## TECHNICAL MEMORANDUM

То	Tom Bird (GCC), Sarah Vance (GCC)	Ref #	2020-05-035-TM-2
сс		Date	3/19/2020
From	Landon Beck, Terry Gulliver		
Subject	Response to 2 <sup>nd</sup> 2018 King Coal Mine AHR DRM 2020	IS Revi	ew dated February 25,

This technical memorandum is the response to the Colorado Division of Reclamation, Mining and Safety (DRMS) comments and questions regarding the 2018 Annual Hydrology Report (AHR) for King Coal Mine presented in a letter to Tom Bird at GCC Energy, LLC, dated February 25, 2020.

Figure 1. 2013 Vista del Oro subdivision water quality sample location map.

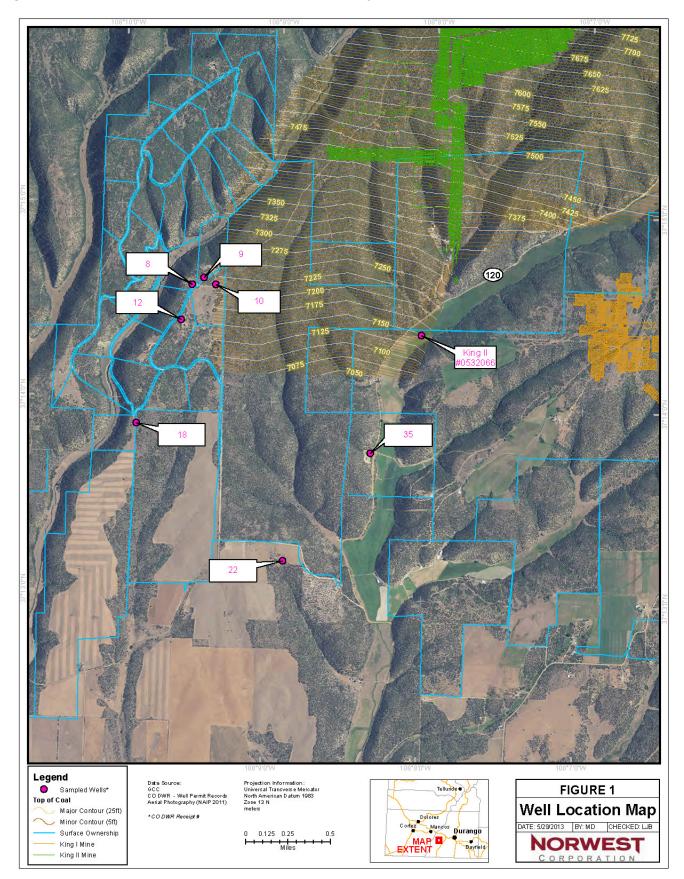
Point 2 relates to high pH values observed in bedrock groundwater wells. It should be noted that the comment in the previous RHS response dated February 13, 2020 about pH being variable at low solute concentrations was meant to apply to some ditch water samples. When salinity is low sometimes the ionic/electric interactions are "poorly poised" and the potential in a measuring electrode may drift. Although the pH of pure water at 25C is 7.0, a meter may drift between a point high or low. This does not apply, however, to aquifer water which can be relied on to have sufficient salinity for stable measurement.

In 2013 GCC commissioned a baseline water quality study of nearby Vista del Oro subdivision domestic water wells, for well owners that were interested on a voluntary basis. The data from this study is presented in **Table 1** and the corresponding sample location map is **Figure 1**. These analyses included lab-measured pH. The pH in Mesa Verde strata is typically between 8 and 9, as shown in the **Figure 2**. The GCC compliance hydrologic monitoring location map is presented as **Figure 3**. Note that 2013 study wells #8, #9, and #10 are in the immediate vicinity of the MW-4 wells and #12 is within about a <sup>1</sup>/<sub>4</sub> mile of the MW-4 wells. Well #18 is within <sup>1</sup>/<sub>2</sub> mile of the MW-3 wells. The full study can be found at:

This study further supports a conclusion that elevated pH in some GCC bedrock compliance monitoring wells is natural and should be considered baseline. RHS directs DRMS to review the 2019 AHR for interpretation and discussion of the bedrock recharge areas which delineate the dry King II Mine workings from the down-dip saturated Menefee formation further documenting the lack of the groundwater advection process potential from King II underground workings.
